**TOWN OF BAY HARBOR ISLANDS  
MORRIS N. BROAD COMMUNITY CENTER  
1175 95TH STREET  
BAY HARBOR ISLANDS, FL 33154**

**DESIGN REVIEW BOARD**

**November 12, 2024  
7:00 PM**

1. Request for approval for an exterior renovation for “Shani Kagan & Beaujon Davidson” located at 1231 101 Street, Lot 15 of Block 25. On April 16, 2024, June 17, 2024, and October 1, 2024, the Board deferred the project. The owners have submitted the revised plans. The resubmittal package meets minimum code requirements and appears to include the information requested by the DRB. The owners are proposing to renovate the existing exterior house facade with a raised front entry & foyer / wood-appearing stucco siding and new doors and window locations. Enclosed please find the site plan, narrative and elevations. Item #1.

**A3**

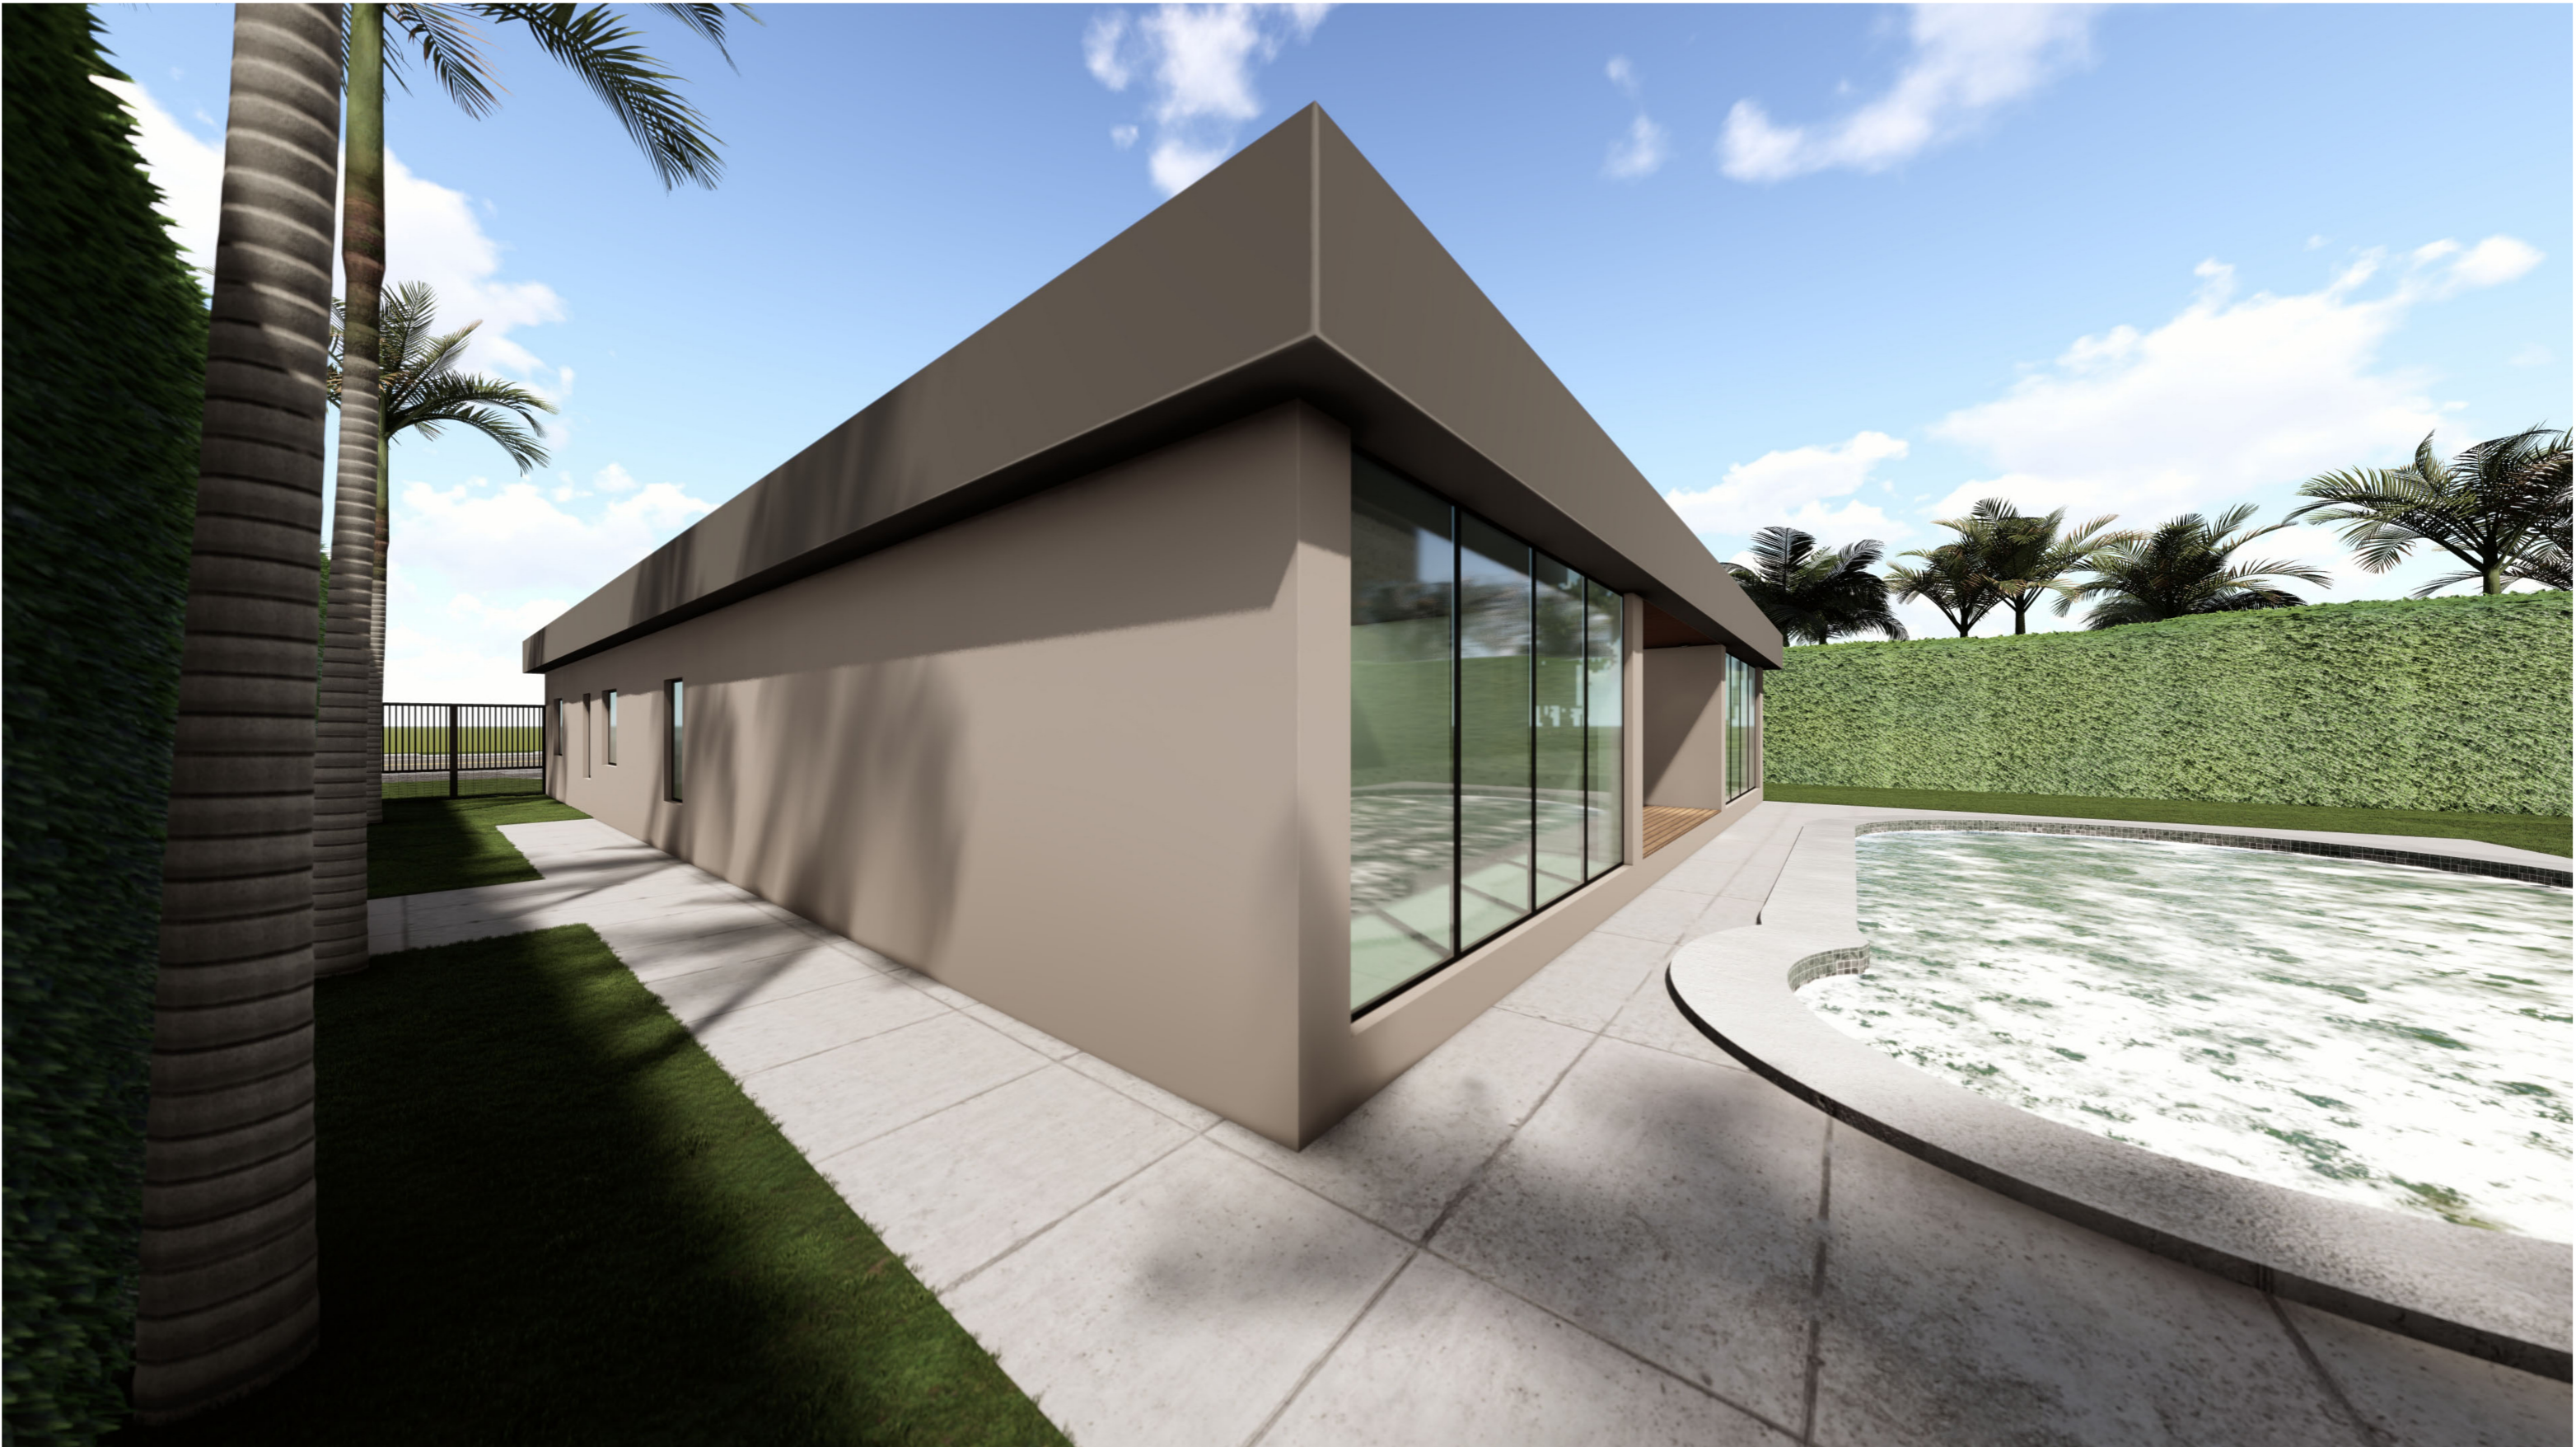
Chair Hurwitz asked about the information in Pages A2.3 and A3 of the plans as the isometrics do not match. Mr. Bitton stated that they match.
